Inspection Report Minerals Regulatory Program

Mine Name: DKG Quarry
Operator Name: Diamond K Gypsum

Permit number: M/015/041
Inspection Date: November 22, 2005
Time: 11:00 AM to 12:20 PM

Photo 1. The operator will try to knock down the pile of waste material in the center-right of this photo and cover it with soil.

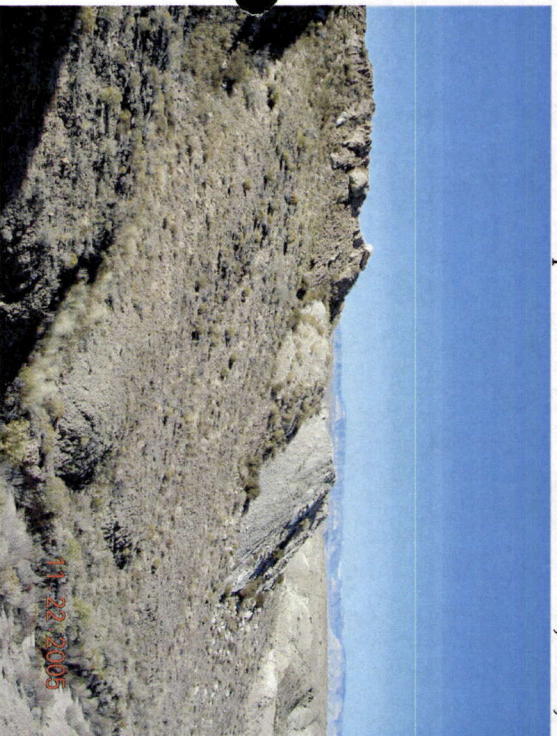
Photos 1 and 2 show a pile of waste material (mostly gypsum, it appears) that the operator will grade. This will mean disturbance of a slightly larger area.

Photo 2. Another view of the waste material shown in Photo 1.

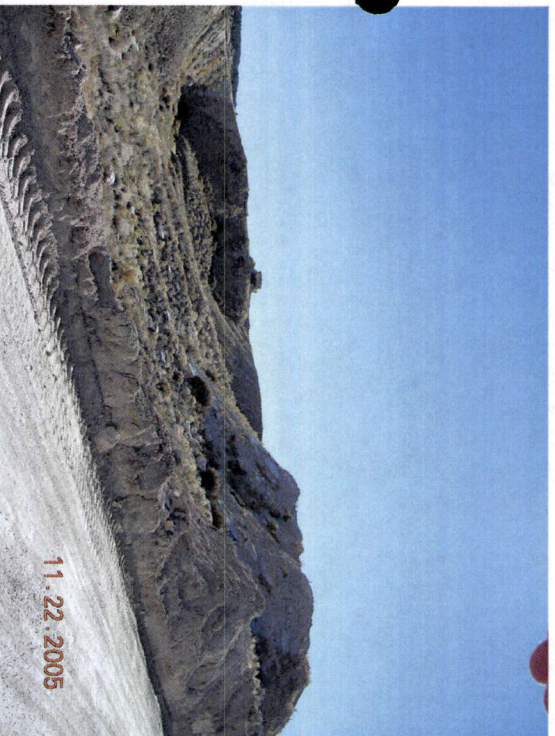
Photo 3. This mound is a rock outcrop that looks natural from this angle but not from the other side. This outcrop will be left.

The drainage near the center of this photo is blocked by the road in the foreground and also by the regraded mine. This drainage looks larger than it is; it only extends about 100 yards above the reclaimed area.

Photo 6. This shows the boundary between the area being reclaimed and the active mine. Runoff from the reclaimed area would flow on to the active mine area, but the operator intends to build a berm to divert this water to a natural drainage.

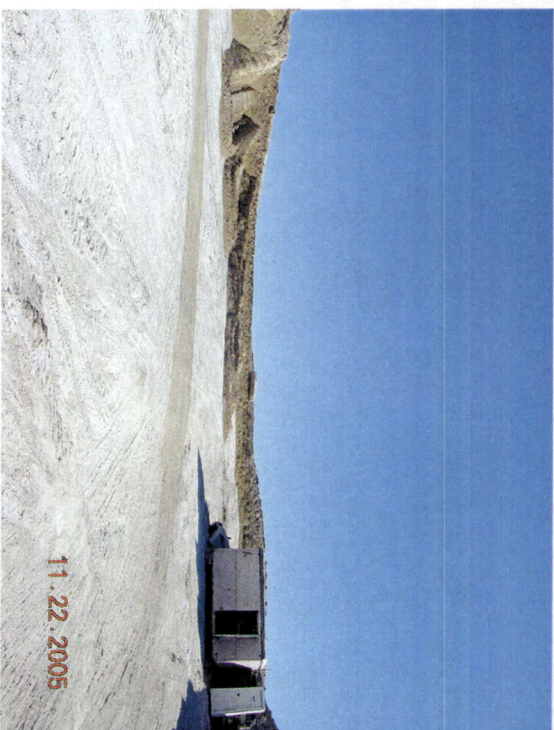
Photo 6 shows the boundary between the area being reclaimed and the active mine. The area being reclaimed is sloped so runoff from this area would go into the active mine which the operator does not want. The operator intends to build a berm across this boundary to divert runoff into a natural drainage channel.

Photo 9. The operator intends to construct a small pond in this area to hold runoff from the upper part of the active mine.

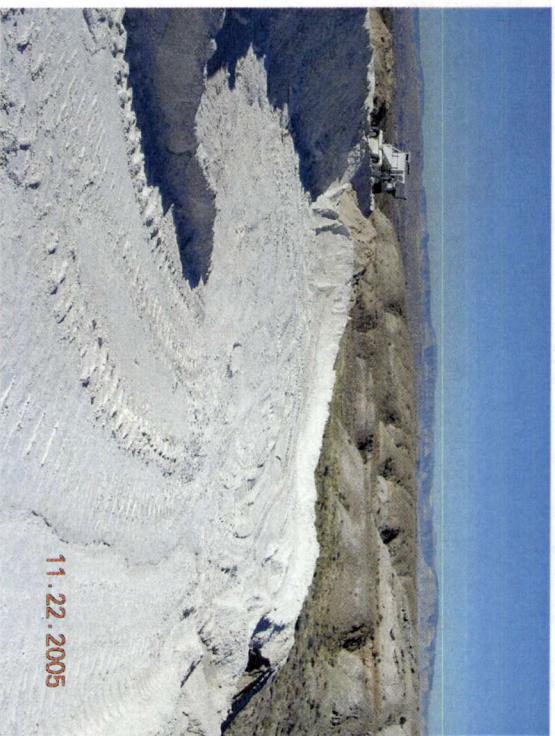
The operator has had troubles with runoff from the active mine eroding the berms and the outslopes on the north side of the mine. This has added sediment to the runoff, but it has also caused problems for equipment operators. Mr. Henry proposed to use the rotomill to build a ditch along part of the north side of the quarry that would divert water to a catch basin (Photo 9). (The area shown in Photo 9 will need to be modified to make it more suitable as a pond.) The outlet from this pond would be placed so there would be as little drop as possible to the adjacent natural drainage channel.

There is already a depression at the lower end of the quarry that serves as a catch basin (Photo 10), and this appears to be large enough that it has not caused problems.

I suggest that the operator install a notched silt fence to serve as the outlet for the upper catch basin. This would need to be keyed in to the embankment so it doesn't wash out.

Photo 10. A depression in the lower portion of the active mine.
